SERVICE BULLETIN

FADEC MANUAL SWITCH GUARD MODIFICATION

All McDonnell Douglas Helicopter Systems (MDHS) MD600N helicopters, serial number RN003 thru RN044.

Figure 1. ECU Switch Guard Modification.

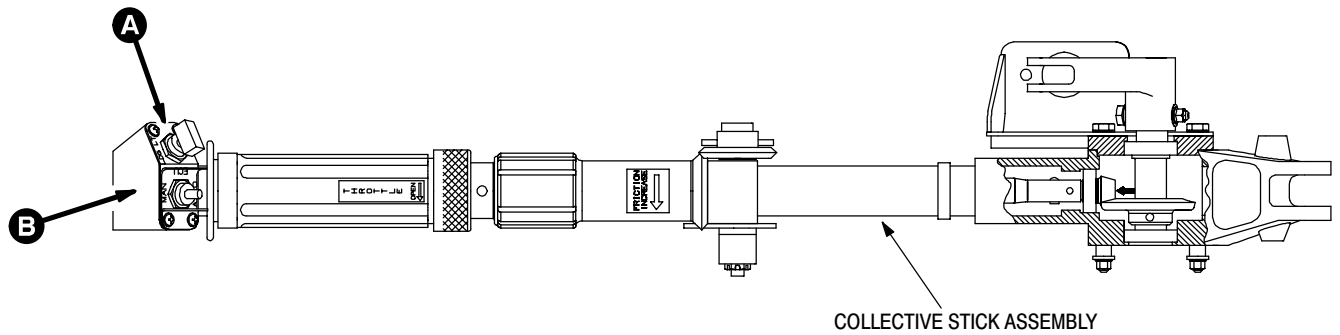
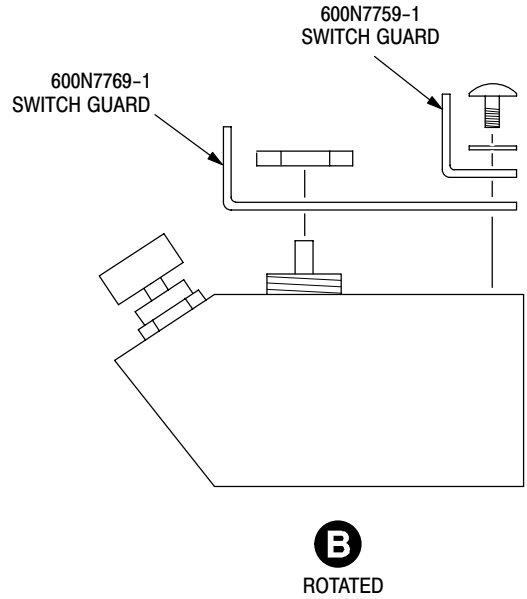
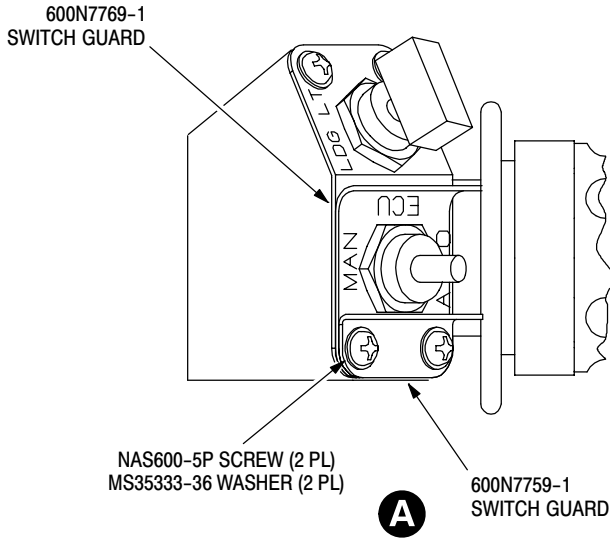
To install an additional guard near the Engine Control Unit (ECU) (manual/auto) switch located on the collective stick assemblies. The new guard provides additional protection against inadvertant ECU switch activation. Failure to comply with the requirements of this Bulletin may result in the switch being turned to manual mode during flight which could cause unanticipated speed-up or slow down the engine with associated changes in rotor RPM leading to possible overspeed.

Procedures in this Bulletin provide owners and operators with information pertaining to adding an additional guard to the collective stick assemblies noted above. The additional guard will add protection to both sides of the switch.

- (1). Remove existing switch guard (P/N 600N7759-1)
- (2). Remove nut securing the switch.
- (3). Place the new switch guard (P/N 600N7769-1) over the switch and reinstall switch nut.
- (4). Place the old switch guard on top of new guard and install washers and screws provided by MDHS.
- (5). Record compliance to this Service Bulletin in the Compliance Record section of the helicopter Log Book.
